# DART

### TEST FIXTURE SPRAG CLUTCH

TEST FIXTURE SPRAG CLUTCH

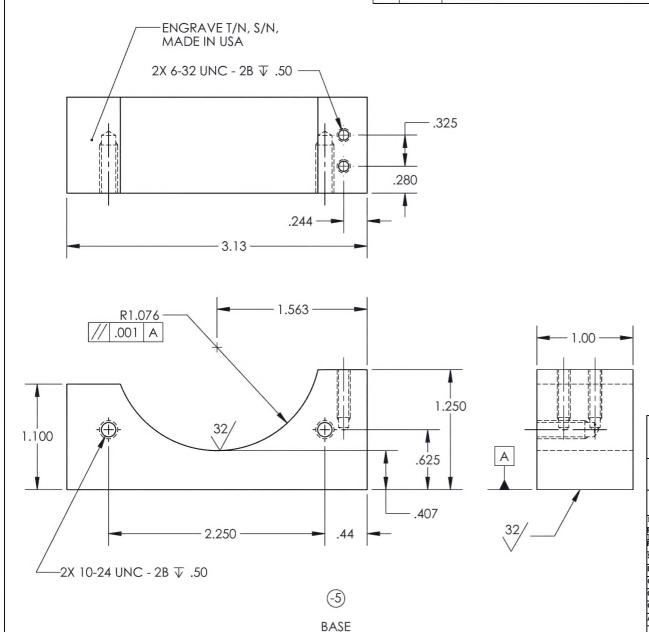
REVISIONS			
REV	ECR	DATE	INITIAL	APPROVED	
1		-5 CH'D 6-32 HOLE LOCATION & LENGTH.	8/14/2000		
2		-5 CENTER OF R1.076 MOVED TO PART MIDPOINT .	12/17/2003		
3		-5 CH'D HOLE LOCATION FROM .46 TO .44.	3/28/2006		
4	16-0009	<b>-5</b> CH'D DIM WAS 10-24 NC .50 DEEP X 2 IS 2X 10-24 UNC -28 $\blacktriangledown$ .50, WAS 6-32 NC .50 DEEP X2 IS 2X 6-32 UNC -28 $\blacktriangledown$ .50, ADDED ENGRAVE NOTE, DELETED -3 FROM THIS PART, CH'D MATERIAL WAS STEEL IS 1018/1020 CR.	1/29/2016	RJC	JAG

INDICATOR BLOCK

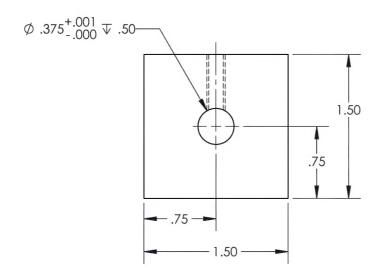
REVISIONS			
REV	ECR	DESCRIPTION	DATE	INITIAL	APPROVED
1		-7 CH'D HEIGHT.	8/14/2000		
4	16-0009	-7 CH'D MATERIAL WAS STEEL IS 6061, CH'D FINISH WAS BLACK OXIDE IS BLACK ANODIZE.	1/29/2016	RJC	JAG
